Access Compliance Report

Public Rights-of-Way

Intersection ID: 30255	Main Street: OLD_IRONSIDE_DR	Cross Street: WYLAM_DILLY_CT	Location:	N
ADA ID: 88F06B692453	Ramp Type: PerpDiag	Initial Pass/Fail: Fail	Overall Compliance: No	Severity Score: 25
Codes/Mitigation Info/Possible Solution		Field Measurements/Component Compliance

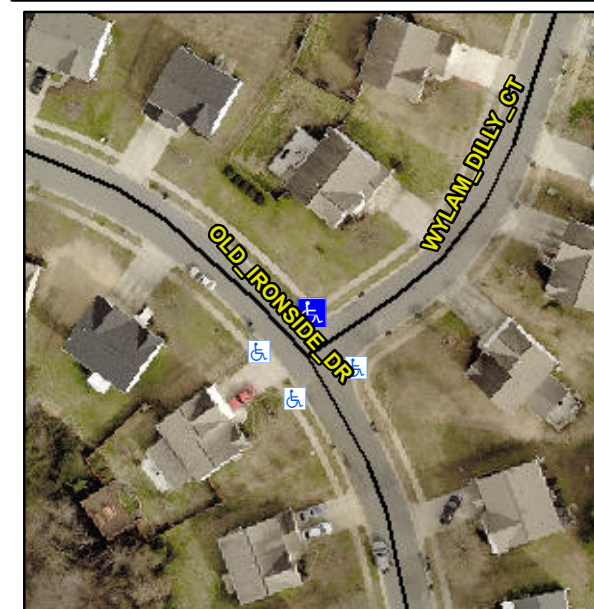
Not Found, R304.2.2

Compliance	Description	Data	Compliance	Description	Data
N/A	Ramp Length (in)	47.0	No	Ramp Slope (%)	14.6
Yes	Ramp Width (in)	55.0	Yes	Ramp XSlope (%)	0.5
N/A	Flare Type LT	N/A	N/A	Flare Type RT	N/A
N/A	Flare Slope LT (%)	N/A	N/A	Flare Slope RT (%)	N/A
N/A	Flare Traversable LT?	N/A	N/A	Flare Traversable RT?	N/A
N/A	Landing Length (in)	N/A	N/A	DWS Provided?	N/A
N/A	Landing Width (in)	N/A	N/A	DWS Contrast?	N/A
N/A	Landing Slope (%)	N/A	N/A	DWS Length (in)	N/A
N/A	Landing X Slope (%)	N/A	N/A	DWS Full Width?	N/A
N/A	Landing Curb? (Y/N)	N/A	N/A	DWS Offset (in)	N/A
N/A	Shared Landing?	N/A			
N/A	Gutter Ponding?	N/A	N/A	Gutter Slope (%)	N/A
N/A	Gutter Lip Ht (in)	N/A	N/A	Gutter X Slope (%)	N/A
N/A	Painted X Walk1?	No	N/A	Painted X Walk2?	No
	X Walk 1 Direction	To W		X Walk 2 Direction	To SE
N/A	X Walk 1 Width (in)	N/A	N/A	X Walk 2 Width (in)	N/A
	X Walk 1 Slope (%)	1.5		X Walk 2 Slope (%)	1.3
	X Walk 1 X Slope (%)	1.9		X Walk 2 X Slope (%)	1.7

Remove & Replace Curb Ramp With Two New Directional Ramps or Equivalent.
